**PLANNED UNIT DEVELOPMENT &
SUBDIVISION STAFF REPORT****Date: September 6, 2007**

<u>DEVELOPMENT NAME</u>	The Oaks at Wolf Ridge	
<u>SUBDIVISION NAME</u>	The Oaks at Wolf Ridge Subdivision	
<u>LOCATION</u>	1503 and 1529 Wolf Ridge Road (West side of Wolf Ridge Road, 450'± North of Moffett Road, extending to the East terminus of Bristol Avenue and the South terminus of La Pine Drive)	
<u>CITY COUNCIL DISTRICT</u>	Council District 1	
<u>PRESENT ZONING</u>	R-1, Single-Family Residential	
<u>AREA OF PROPERTY</u>	22.7± acres	72 Lots
<u>CONTEMPLATED USE</u>	Planned Unit Development Approval to allow reduced lot sizes and reduced side yard setbacks in a single-family residential subdivision	
<u>TIME SCHEDULE FOR DEVELOPMENT</u>	Immediately upon approvals	
<u>ENGINEERING COMMENTS</u>	Show park as common area. If drainage-way east of pond accepts public water, provide drainage easement Analysis of drainage structure under Wolf Ridge Road should be analyzed for capacity; if undersized, the structure should be replaced, with Engineering Department-approved design. It is the responsibility of the applicant to look up the site in the City of Mobile (COM) GIS system and verify if NWI wetlands

SITE PLAN

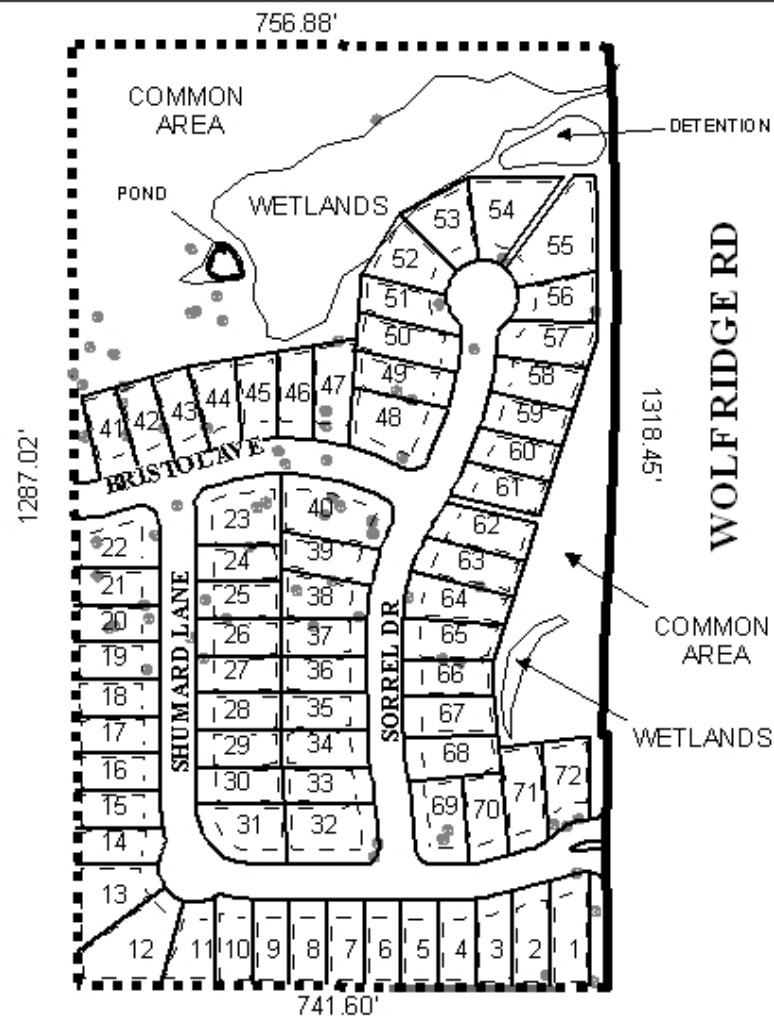
Wolf Ridge Road, which has an existing right-of-way of 80', is shown as a major street on the Major Street Plan component of the Comprehensive Plan, and as such requires a minimum right-of-way of 100'. Therefore, dedication sufficient to provide a minimum of 50' from centerline should be required. Additionally, as Wolf Ridge Road is shown as a major street, access management is a concern.

The common areas will include a pond, wetlands, and some number of untouched old growth live oaks and magnolias. As the site contains wetlands, it could be considered environmentally sensitive. Therefore, approvals from all applicable federal, state and local agencies should be obtained prior to the issuance of any permits or the commencement of clearing or land disturbing activities.

In addition to the larger trees located in the proposed common areas, which should all be granted preservation status, there are several other large live oaks located on the property. Specifically 48" live oaks on Lots 47 and 63, a 46" live oak on Lot 22, 40" live oaks on Lots 38, 21 and 2, all of which should be granted preservation status, all work under the canopies is to be permitted and coordinated with Urban Forestry, removal to be permitted by Urban Forestry only in the case of disease or impending danger. Urban Forestry has visited the site and noted a 60" live oak on Lot 48 that is in questionable condition, and could pose a threat due to existing damage. Therefore, this 60" tree is not included in the request for preservation status. There are also other large live oaks ranging from 24" to 38" throughout the property. These trees should be protected, as required by ordinance, which means that a permit from Urban Forestry is required prior to trimming and/or removal. The difference between preservation status and protected status is that preservation status allows removal only in the case of disease or impending danger. Protected trees may be removed for other reasons, such as their specific location on the site renders the site undevelopable or the tree falls within the footprint of the proposed building will little or no option for modifications.

The plat indicates a cul de sac at the North terminus of proposed Sorrel Drive. The cul de sac as proposed would have a 100' radius. While this radius meets the minimum standards of the Subdivision Regulations, Appendix D of the international Fire Code requires a larger cul de sac. The Fire Department and City Engineering Department have revised the typical layout and section for cul de sacs to comply with Appendix D, and thus a 120' radius is now required. As the Subdivision Regulations are minimum standards, and other City Codes have a greater standard, the greater standard must be applied. Therefore, the radius for the cul de sac at the Northern terminus of Sorrel Drive must be increased to 60'. This increase should not have a substantial impact on those lots which are adjacent.

The preliminary plat contains a note stating that maintenance of all common areas shall be the responsibility of the Oaks at Wolf Ridge property owners association, which should be retained on the final plat, if approved. The preliminary plat also contains a note stating that all lots shall access the interior subdivision streets only. This note should be expanded to include common areas as well.

1. dedication of sufficient right-of-way to provide a minimum of 50' from the centerline of Wolf Ridge Road;
2. construction and dedication of new streets to City Engineering standards, including revision of the proposed cul de sac to comply with Appendix D of the International Fire Code;

3. compliance with Engineering Comments (Show park as common area. If drainage-way east of pond accepts public water, provide drainage easement Analysis of drainage structure under Wolf Ridge Road should be analyzed for capacity; if undersized, the structure should be replaced, with Engineering Department-approved design. It is the responsibility of the applicant to look up the site in the City of Mobile (COM) GIS system and verify if NWI wetlands are depicted on the site. If the COM GIS shows wetlands on the site, it is the responsibility of the applicant to confirm or deny the existence of wetlands on-site. If wetlands are present, they should be depicted on plans and/or plat, and no work/disturbance can be performed without a permit from the Corps of Engineers. Must comply with all storm water and flood control ordinances. Any work performed in the right of way will require a right of way permit);

6. the note stating that all lots shall access the interior subdivision streets only be expanded to include common areas; and
7. placement of a note on the final plat stating that the 60" live oak on Lot 48, 48" live oaks on Lots 47 and 63, a 46" live oak on Lot 22, 40" live oaks on Lots 38, 21 and 2, all of which should be granted preservation status, all work under the canopies is to be permitted and coordinated with Urban Forestry, removal to be permitted by Urban Forestry only in the case of disease or impending danger; and other large live oaks ranging from 24" to 38" throughout the property are protected as required by ordinance, which means that a permit from Urban Forestry is required prior to trimming and/or removal;
